Independent Design Peer Review

CROWN STREET, SURRY HILLS DEVONSHIRE ST TO OXFORD ST UPGRADE PEER REVIEW

CITY OF SYDNEY
MARCH 2023
FINAL

STATUS	FINAL
ISSUE	D
DATE	03,03,2023
PREPARED BY	GJ/ZY
APPROVED BY	JP

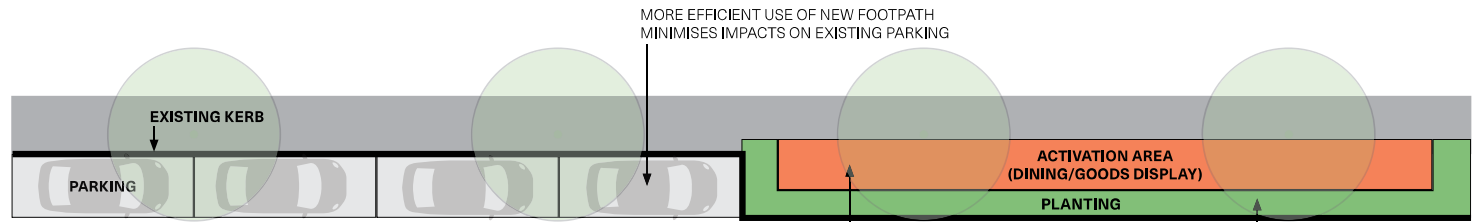
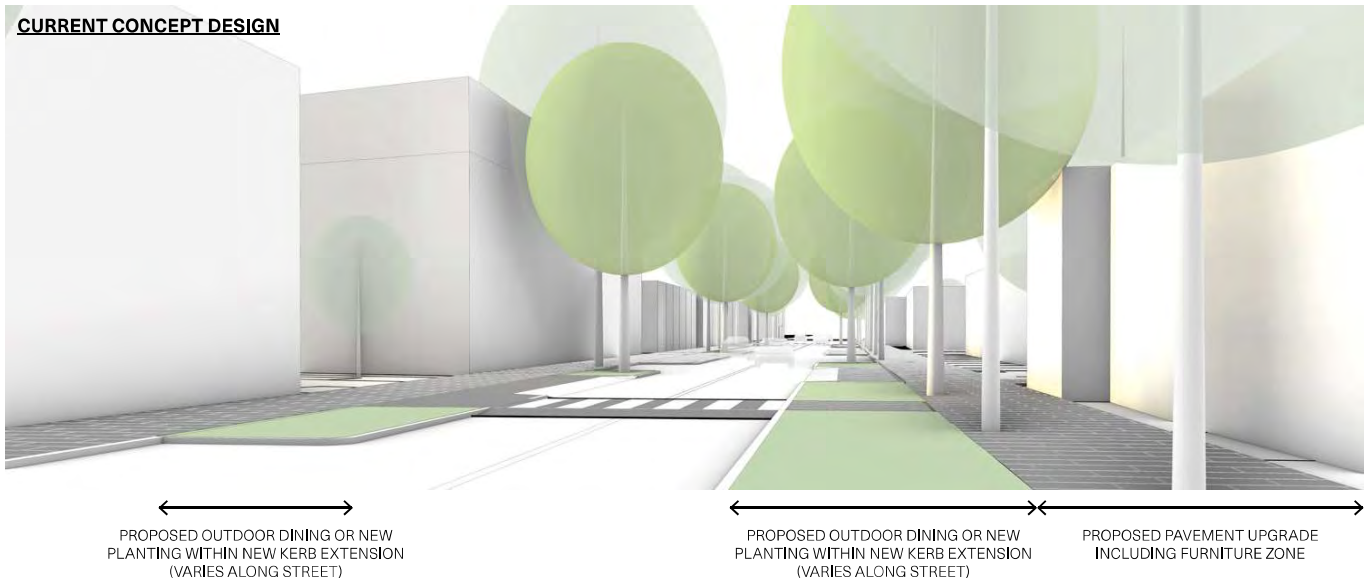
The current concept design proposes a significant gain in public space within the verge - the result of kerb extensions and lane narrowing along much of Crown Street.

The resulting public domain design proposes a binary approach to the design of this additional public space, creating large areas of outdoor dining interspersed with large areas of planting, both of which occupy the full width of the proposed kerb extension.

We believe there is an opportunity to adopt an alternate arrangement to public domain in the verge that:

- Provides more opportunities for greening and tree planting
- Creates flexible areas of pedestrian paving—what we call Activation Areas—that can be used for outdoor dining, displaying goods, or other opportunities that the local and business community may develop over time
- Provides buffer planting between Activation Areas and moving vehicular traffic in adjacent travel lanes
- Provides an efficient use of verge space that allows for reducing impacts on existing car parking supply.

Crown Street Peer Review Plan 1 of 8

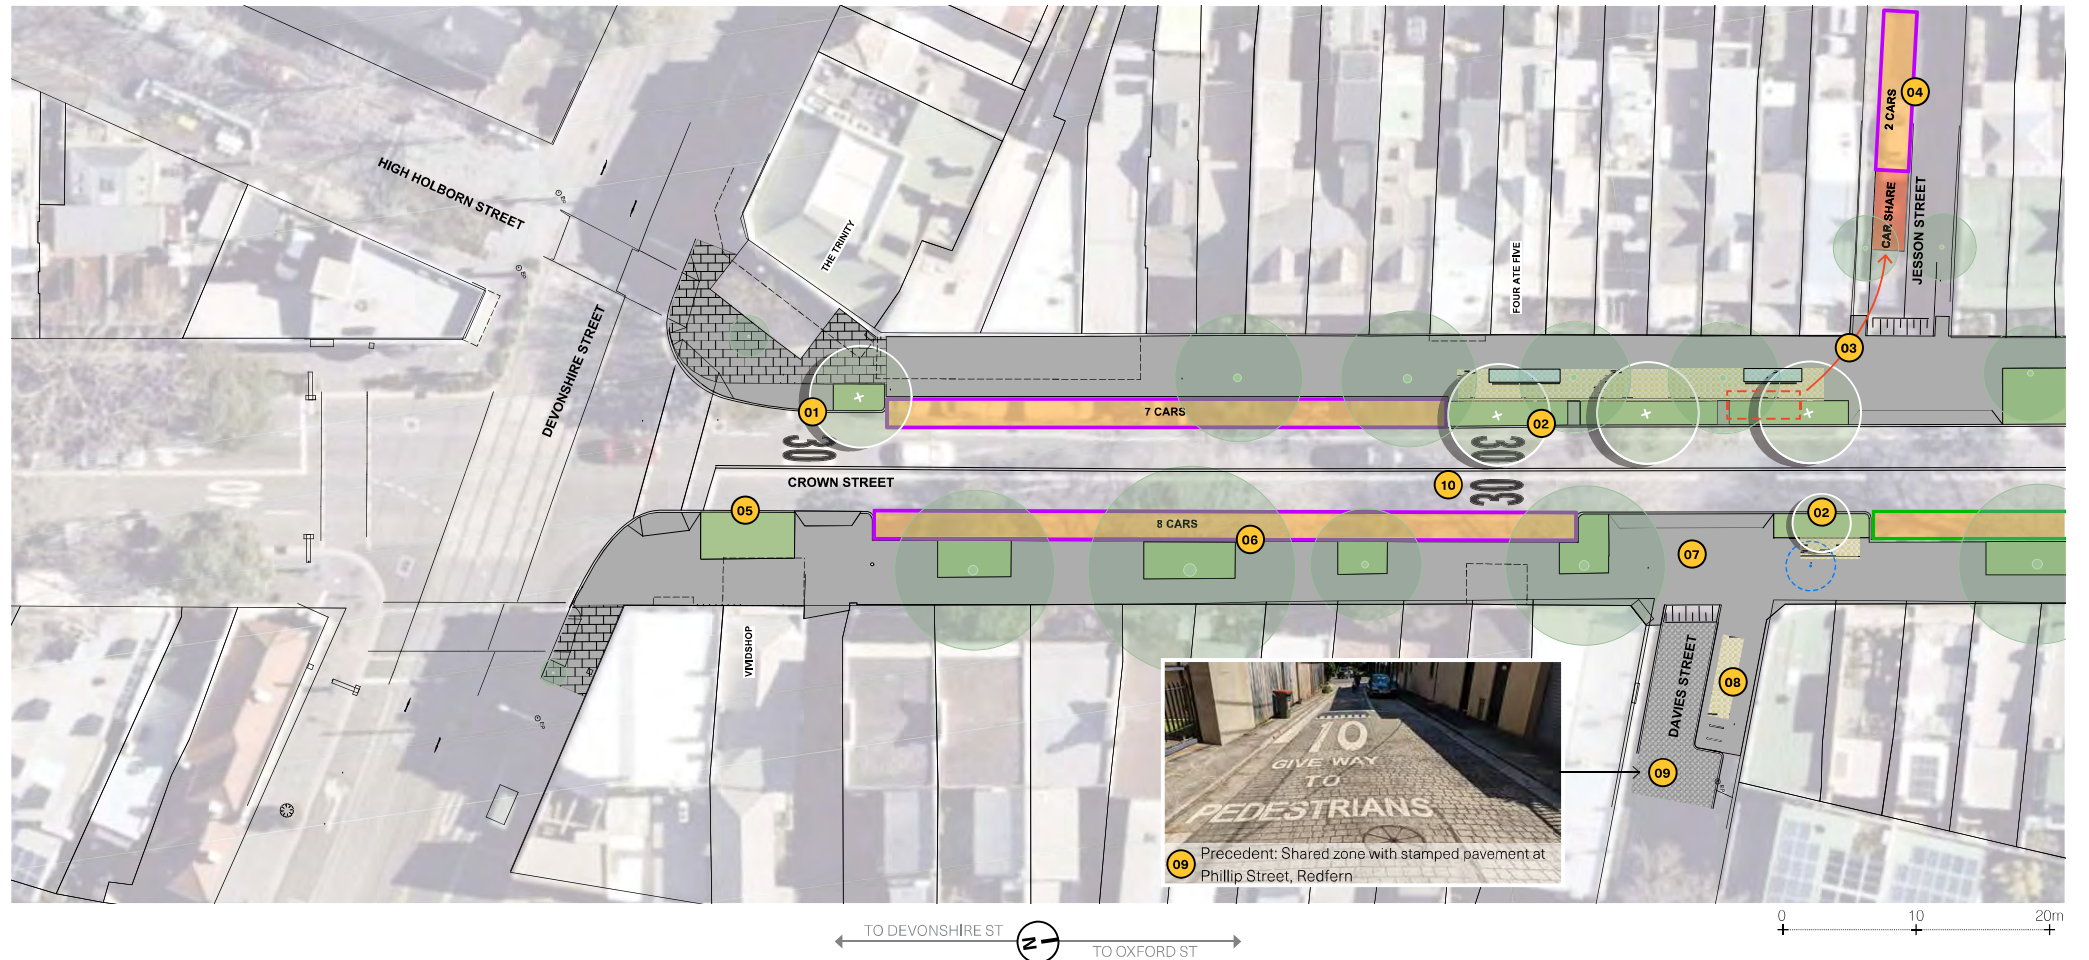
1. Kerb extension and new street tree as per AECOM concept design.
2. New kerb extension to create activation area with kerbside planting and additional street trees at existing commercial premises.

3. Relocate 1 no. existing car share parking space to Jesson St.
4. Convert 2-3 no. existing unmarked 2P parking spaces on Jesson St to 2 no. marked 2P parking spaces.

5. Kerb extension to provide additional pedestrian paving and planting at intersection, with operations to intersection to remain unchanged (subject to TfNSW approval).

6. Kerb alignment adjusted (to minimum compliant parking space width) to maximise footpath and planting space. Increased planting beds to base of existing trees.

7. Continuous footpath treatment and kerb extension at Davies St.
8. Kerb extension to Davies St to provide additional activation area and space for new bike parking.

9. New shared zone with stamped pavement to Davies St, to be consistent with other typical City of Sydney laneway shared zones (subject to further investigation and TfNSW approval).

10. Speed reduction to Crown Street to 30km/h (subject to TfNSW approval).

Crown Street Peer Review Plan 2 of 8

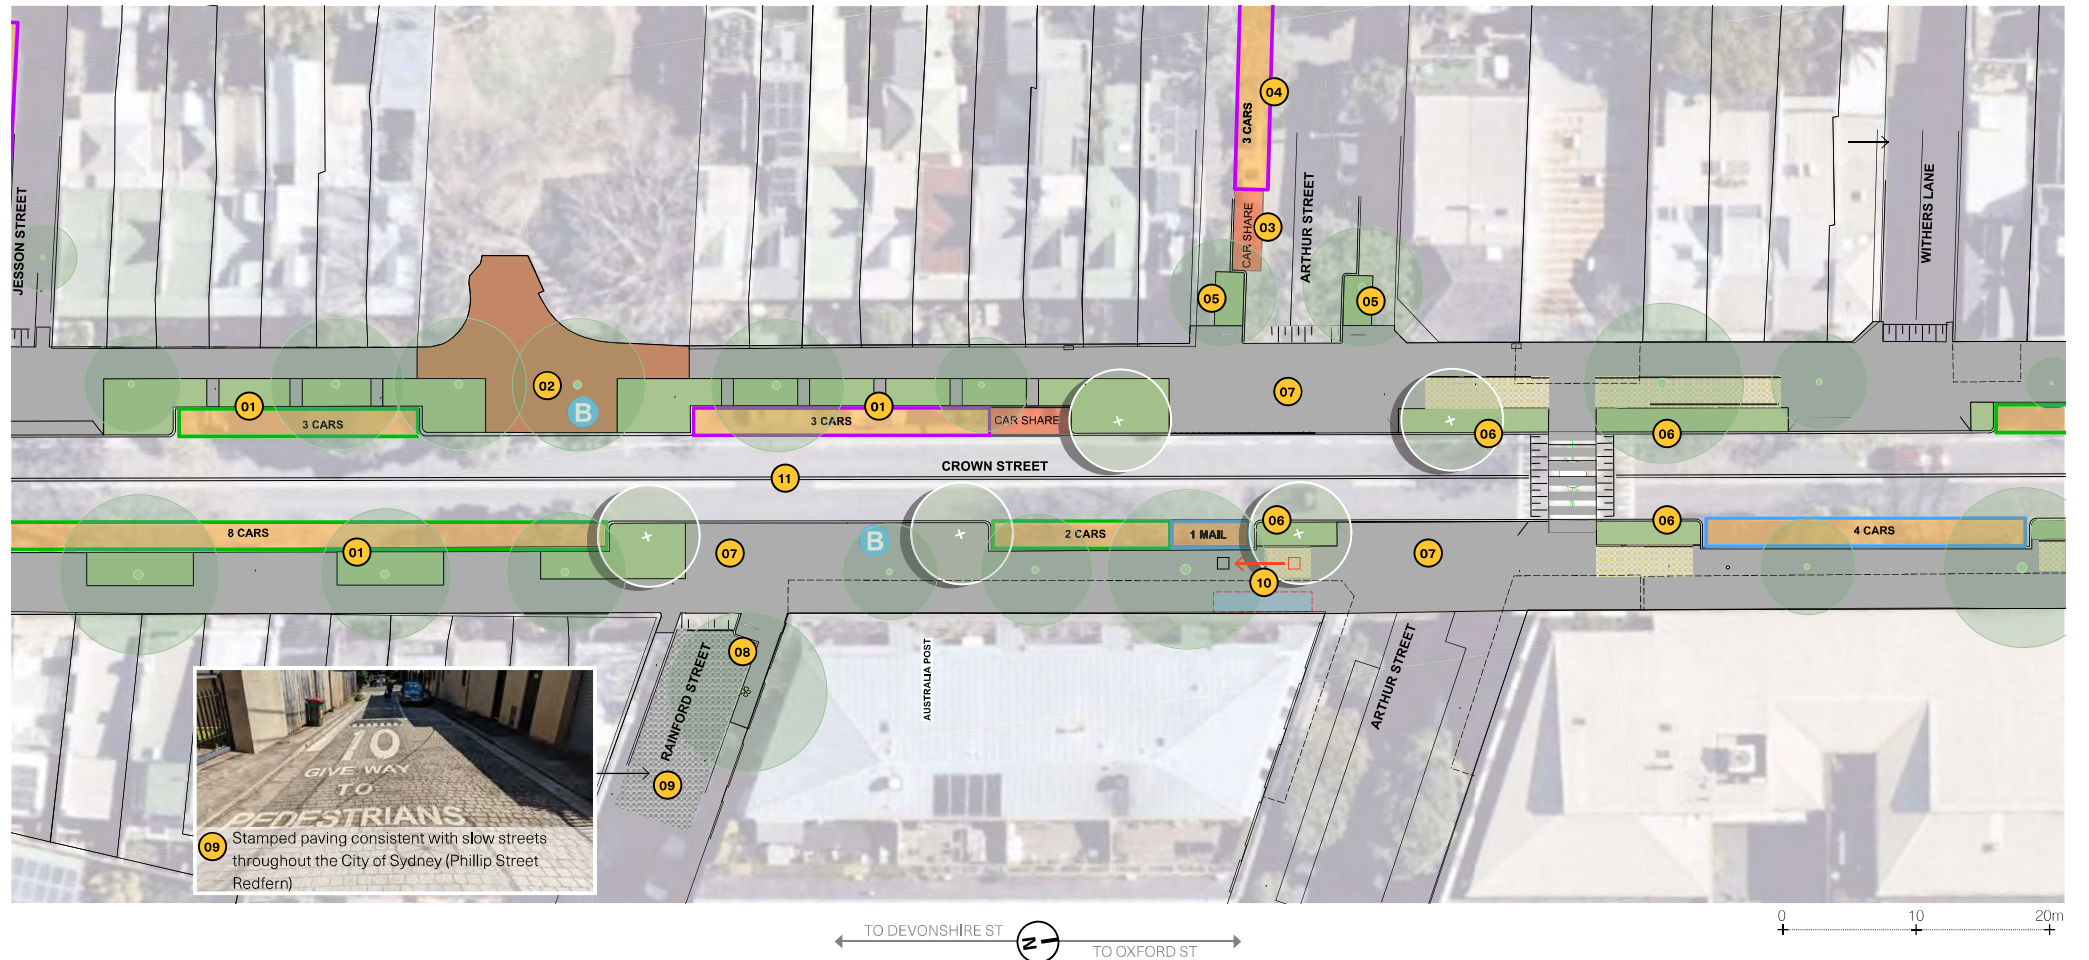
1. Kerb alignment adjusted (to minimum compliant parking space width) to maximise footpath and planting space. Continuous planting bed provided with intermittent pavements for access to parked vehicles.

2. Bus stop 'in the park' - in-lane bus stop located to align with Tudor St park, with existing brick paving to full width of Tudor St lot boundary to be retained.

3. Relocate 1 no. existing car share parking space from outside The Clock Hotel to Arthur St.
4. Convert 4 no. existing unmarked 2P parking spaces on Arthur St to 3 no. marked 2P parking spaces.

5. Kerb extensions to Arthur St to provide additional space for planting and bike parking, and lane narrowing for traffic calming.
6. New kerb extension to create activation area with kerbside planting, and additional street trees at existing commercial premises.

7. Continuous footpath treatment and kerb extension where side streets.
8. Kerb extension to Rainford St to provide additional space for new bike parking.

9. New shared zone with stamped pavement to Rainford St, to be consistent with other typical City of Sydney laneway shared zones (subject to further investigation and TfNSW approval).

10. Minor relocation of existing mail box to provide additional activation area.
11. Speed reduction to Crown Street to 30km/h (subject to TfNSW approval).

Crown Street Peer Review Plan 3 of 8

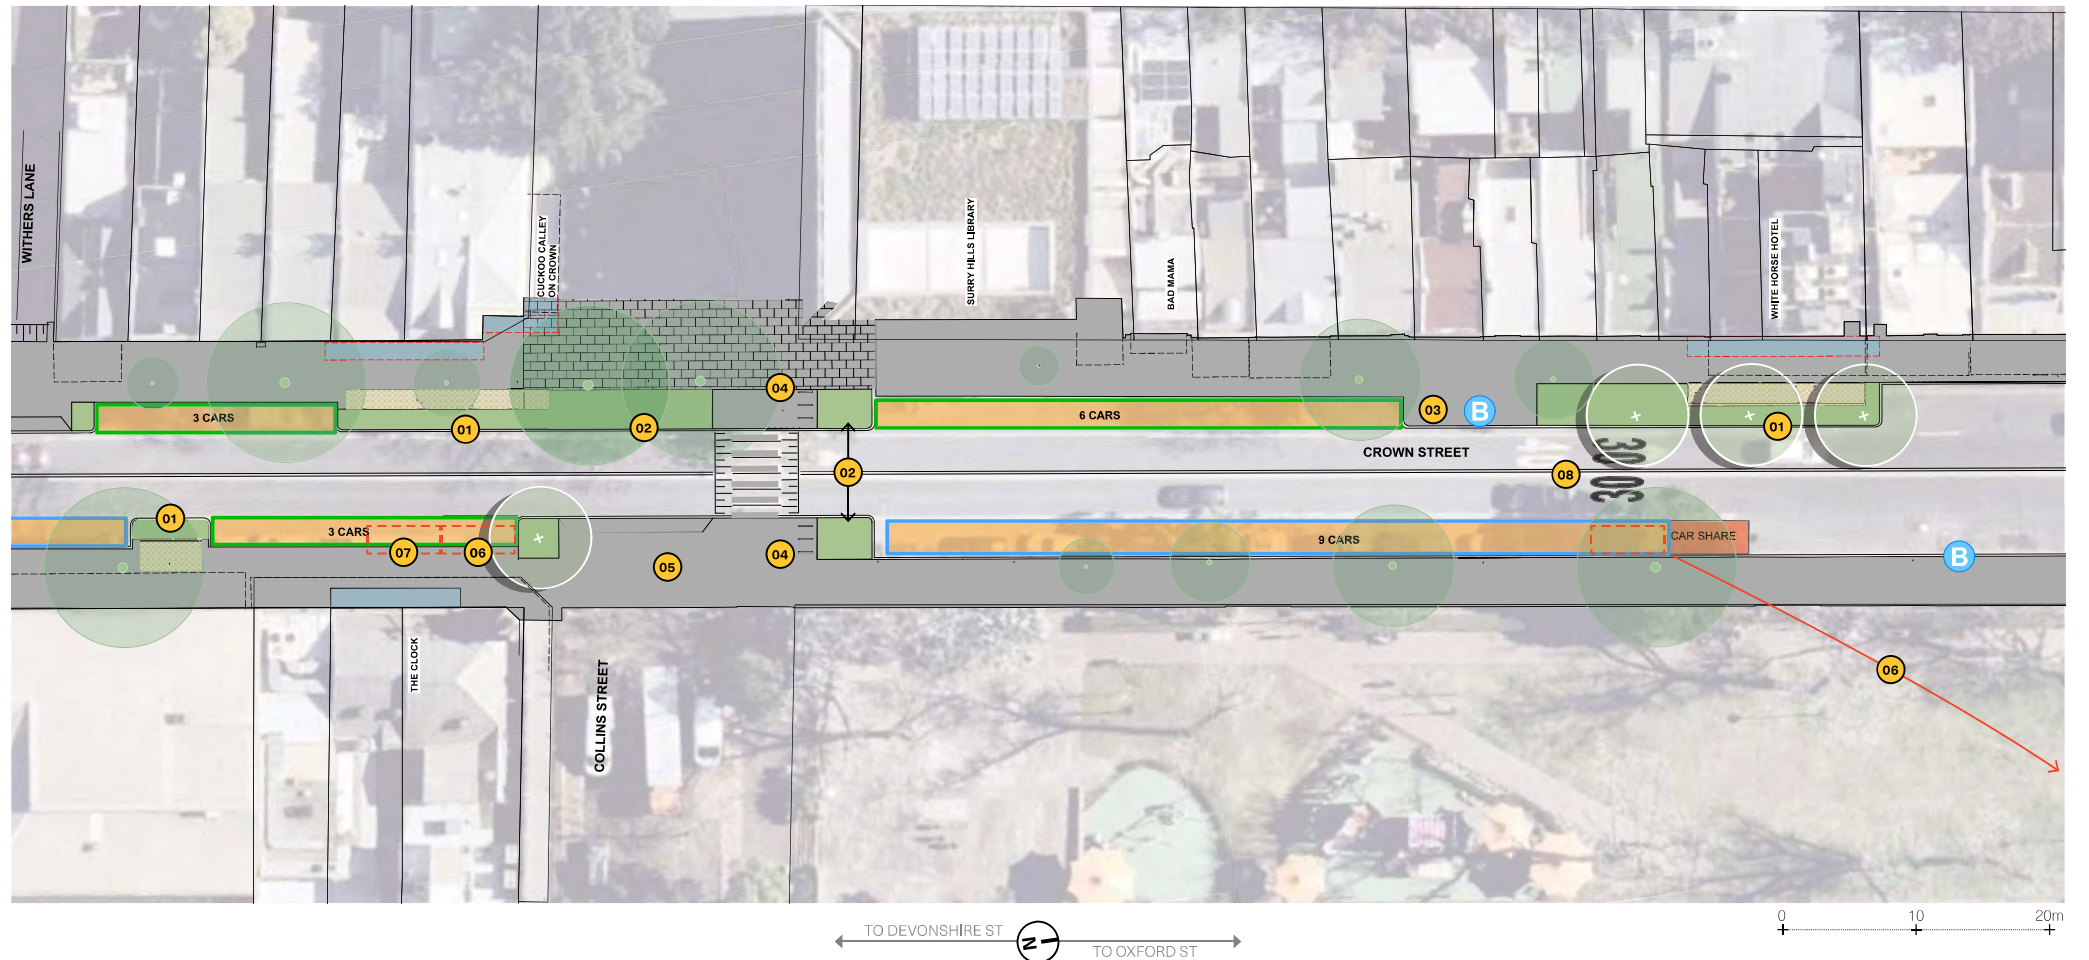
1. New kerb extension to create activation area with kerbside planting, and additional street trees at existing commercial premises.
2. New kerb extensions with additional planting (assess amenity and performance of raingarden application in main street with potential to replace with street planting consistent with approved planting palette).
3. New kerb extension for in-lane bus stop, 9m paving zone shown (to be reviewed at detailed design stage to consider user access requirements).
4. New bike parking a key arrival point to Crown St and point of dismount for cyclists approach via Crown St or Collins St.
5. Continuous footpath treatment and kerb extension at Collins St.
6. Relocate 2 no. existing car share parking spaces to Richards Ln.
7. Relocate 1 no. existing car share parking spaces to Arthur St.
8. Speed reduction to Crown Street to 30km/h (subject to TfNSW approval).

Crown Street Peer Review Plan 4 of 8

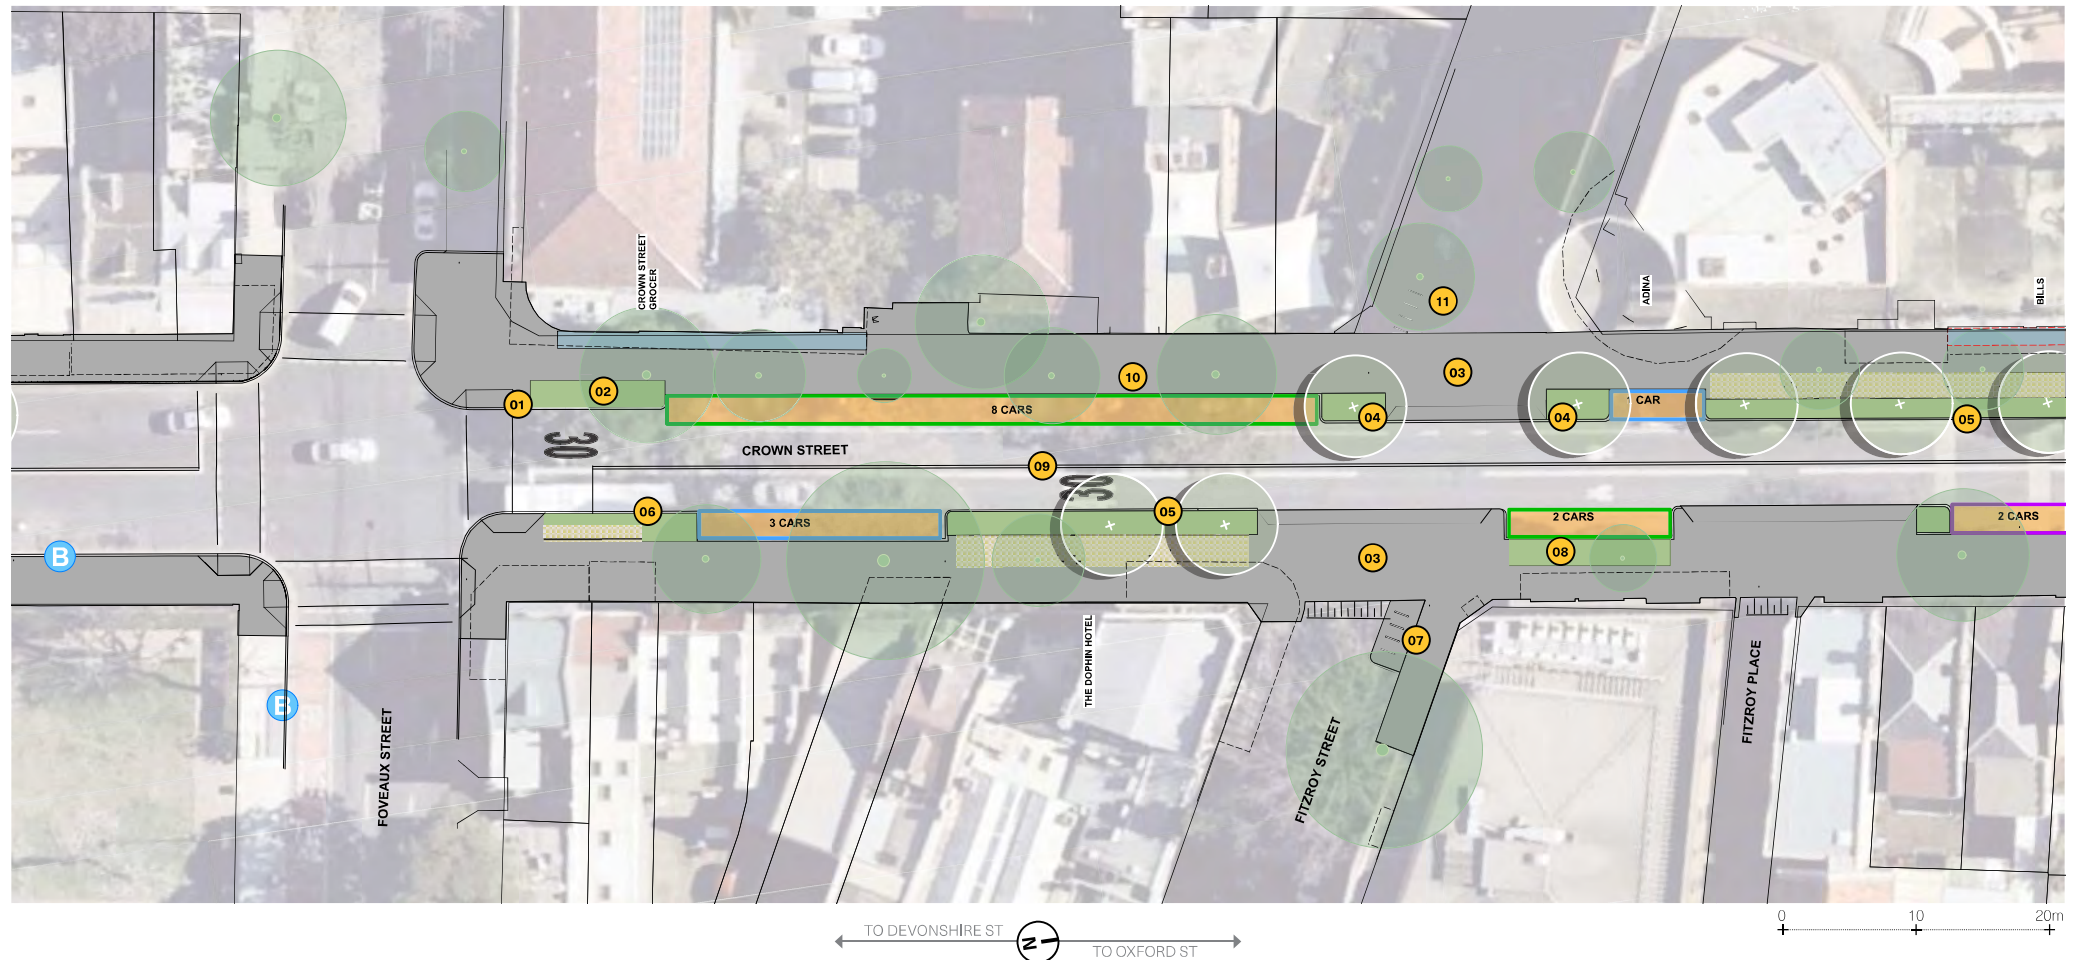
1. Kerb extension as per AECOM concept design.
2. Additional kerbside planting.
3. Continuous footpath treatment and kerb extension at Fitzroy St.
4. Kerb extension with new street tree planting.

5. New kerb extension to create activation area with kerbside planting and additional street trees at existing commercial premises.
6. New kerb extension to provide additional pedestrian paving for activation and planting. Adjustment to signal operations to be investigated (subject to TfNSW approval).

7. Kerb extension to Fitzroy Street to provide additional space for new bike parking.
8. Kerb alignment adjusted (to minimum compliant parking space width) to maximise footpath and planting space.

9. Speed reduction to Crown Street to 30km/h (subject to TfNSW approval).
10. Existing driveway removed as per current concept design.
11. Provide additional bike parking on Arthur St to offset removal/relocation of existing bike parking on Crown St.
